**From:** 樋口 洵 [mailto:m\_higu\_kazu@nexyzbb.ne.jp]  
**Sent:** Saturday, May 31, 2014 10:00 PM  
**To:** Stevens, Gary  
**Subject:** Comments for NUREG/CR-6909

**Tensile and Yield Strength in the Design Fatigue Curves**  
(Comments from Makoto Higuchi)

Figure 1 The relation of Static YS to TS for carbon and low-alloy steels

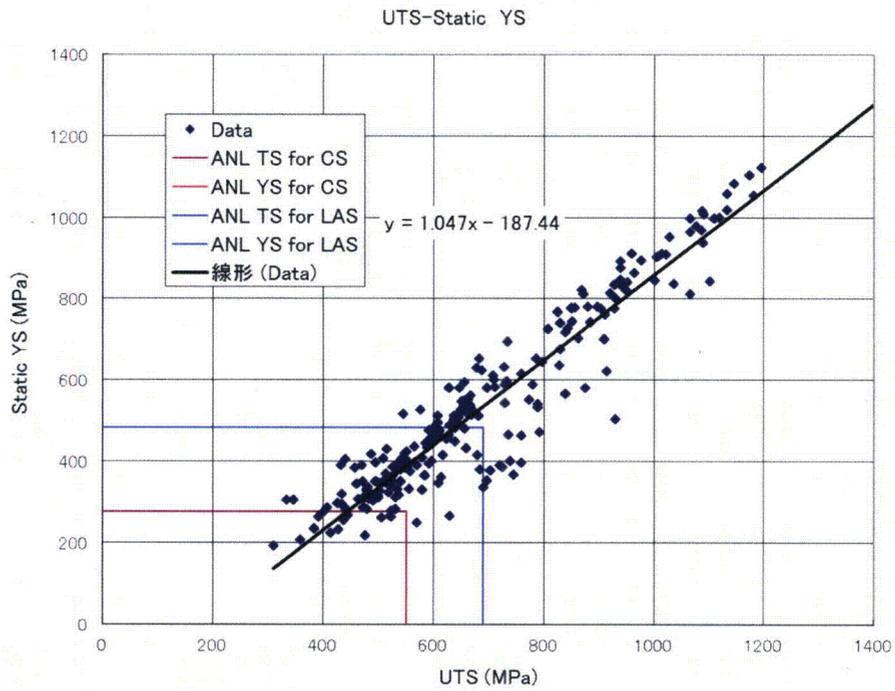
The static and cyclic YS data were obtained from a lot of fatigue and material data for carbon and low-alloy steels and plotted vs. TS as shown in Figures 1 and 2, respectively. In these figures, a good linear relation can be seen and the linear expressions are also shown in the figures. The static YS is higher than cyclic YS in the higher TS region and lower in the lower TS region and thus the trend line is more steep in Figure 1.

In these figures, the ASME values listed in the above table are also shown. In Figure 1, the ASME YS for both of carbon and low-alloy steels are much lower than the trend line, but in Figure 2, the ASME YS for carbon steel is still lower than the trend line but YS for low-alloy steels is much higher than the trend line.

In any rate, the ASME YS are different from actual material data and seems not reasonable and should be re-examined.
